Referee #1

Referee #2

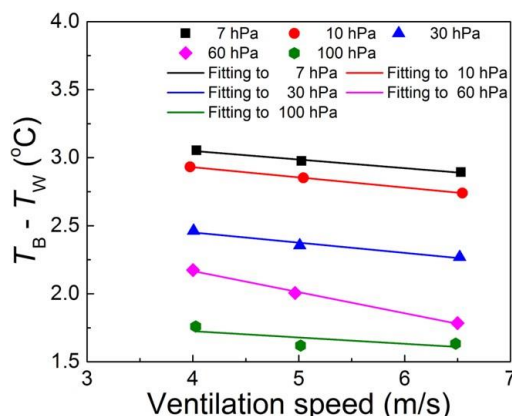
The authors state that “The ventilation speed for five units in Figure 6 is fixed at $5 \text{ m}\cdot\text{s}^{-1}$ and thus the effect of air ventilation cannot be identified. The effect of air ventilation is studied with a separate pair of thermistors”. Given the irregularities in the production process can the values of the standard deviation of the residual for the pair of thermistors (reduced from 4.1% to 3.4% when the air ventilation is actually changed $4\text{--}6.5 \text{ m}\cdot\text{s}^{-1}$) be considered typical? Otherwise I'd suggest the authors to extend the assessment of the effect of air ventilation to a larger number of thermistors.

→ The effect of ventilation is not significant in the range of 4–6.5 m·s⁻¹ as shown in the Figure below and thus the decrease of the residuals is small when Eq. (10) is used to reflect the ventilation effect. Eq. (9) is deduced when the ventilation speed is 5 m·s⁻¹ while Eq. (10) is from 4–6.5 m·s⁻¹ using an average of the sensitivity coefficient (–0.08 °C/(m·s⁻¹)) over the range. The ventilation effect will become significant below 4 m·s⁻¹ because the convective cooling will be weakened as studied by the GRUAN. This remains to be our future study because we have learned that there are some researchers who wants to collect more data with a slow ascent of radiosondes.

Added statement (Line 432-433): Since the radiation correction formula presented in this study is valid for the ventilation speed of 4–6.5 m·s⁻¹, the range should be widened to extend the applicability of the DTR.
